MONTGOMERY COUNTY HISTORIC PRESERVATION COMMISSION
STAFF REPORT

Address:	9900 Falls Road, Rockville	Meeting Date:	6/26/2024
Resource:	Master Plan Site #29/08-002A Perry Store	Report Date:	6/18/2024
Applicant:	Capital One (Ruth Newell, Agent)	Public Notice:	6/12/2024
Review:	HAWP	Tax Credit:	No
Permit Number:	1071828	Staff:	Chris Berger

PROPOSAL: Exterior alterations for ADA accessibility.

Figure 5: The proposed demolition plan and site plan for the parking lot improvements.

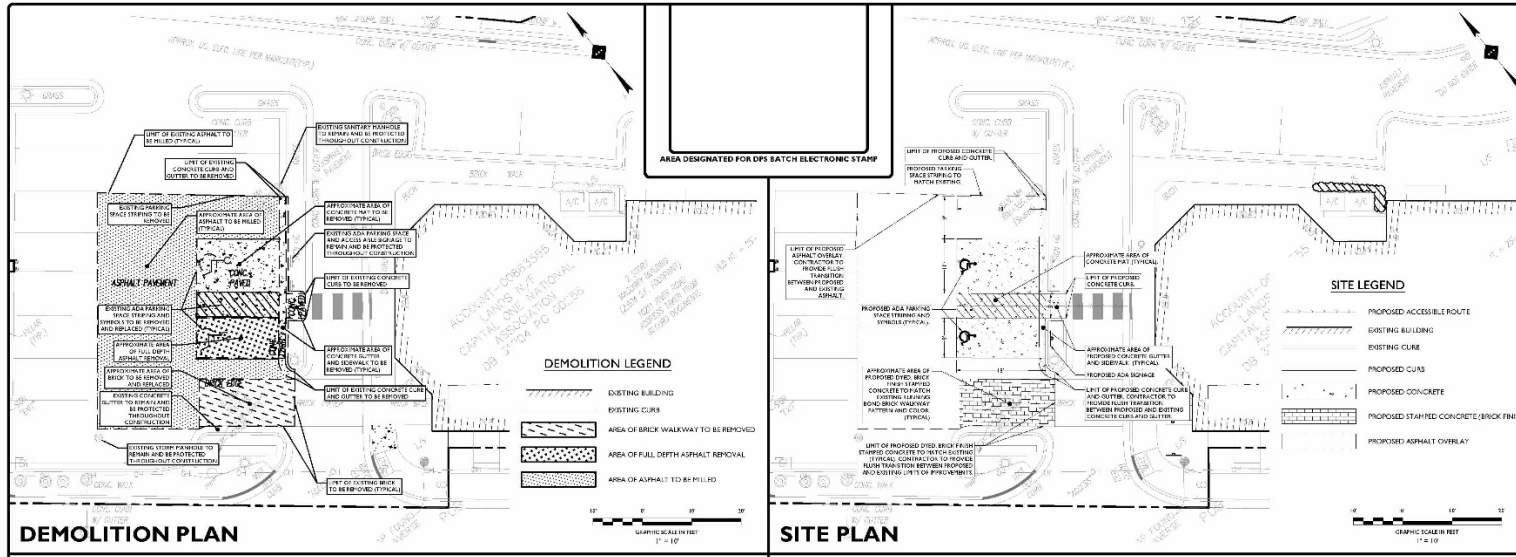
1. Applicant must confirm whether the brick pavers in the parking lot and driveway will be replaced with asphalt or brick-stamped concrete.

The site plan on **Figure 5** for the existing brick parking lot path has a label that states it will be concrete with a stamped brick finish. The demolition plan on **Figure 6** states the brick path will be replaced with asphalt. Staff supports either option but seeks clarification on which will be selected.
